STATE OF ILLINOIS
ILLINOIS COMMERCE COMMISSION

ROCK ISLAND CLEAN LINE LLC	:	
	:	
Petition for an Order granting Rock Island Clean Line	:	
LLC a Certificate of Public Convenience and	:	
Necessity pursuant to Section 8-406 of the Public	:	No. 12-0560
Utilities Act as a Transmission Public Utility and to	:	
construct, operate and maintain an electric	:	
transmission line and authorizing and directing Rock	:	
Island pursuant to Section 8-503 of the Public	:	
Utilities Act to construct an electric transmission line.	:

Direct Testimony of
STEVEN T. NAUMANN, P.E.
Vice President
Transmission and NERC Policy
Exelon Business Services Company

Figure 1

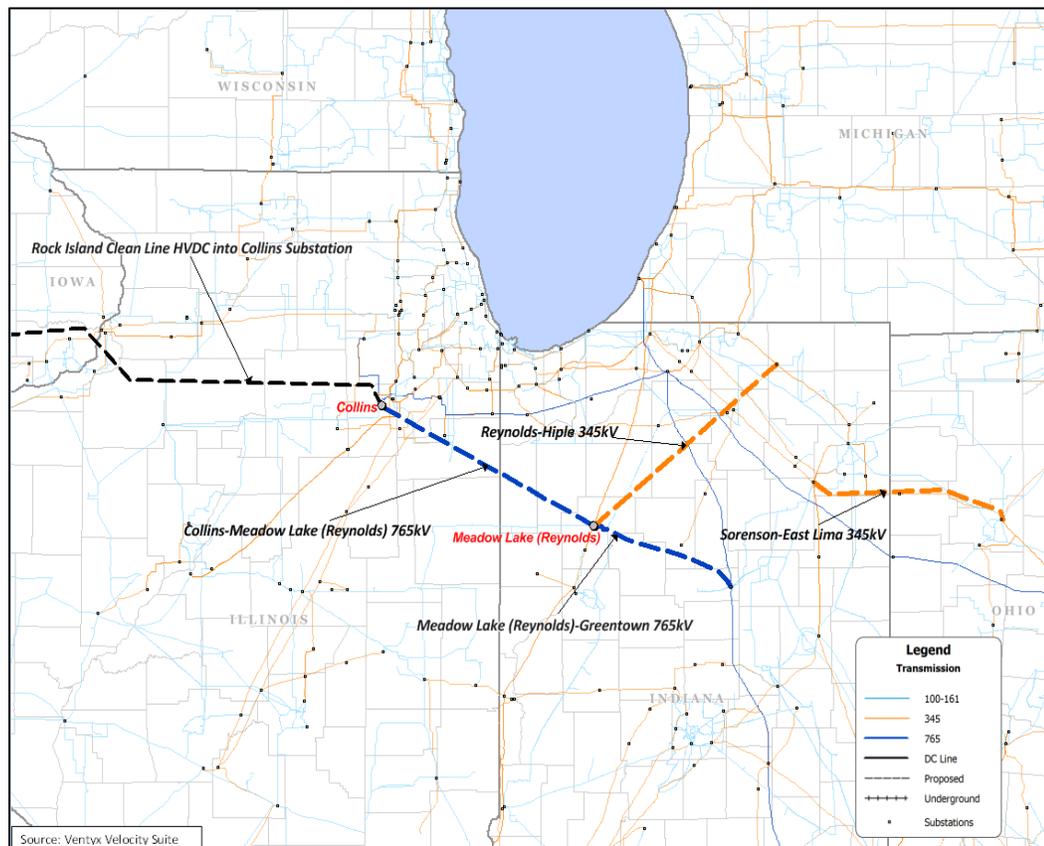
445 765kV, Meadow Lake 765/345kV autotransformers and Reynolds – Hiple 345kV) also
446 are required to assure reliability of the PJM transmission system. The general location of
447 these upgrades is shown below in Figure 1.
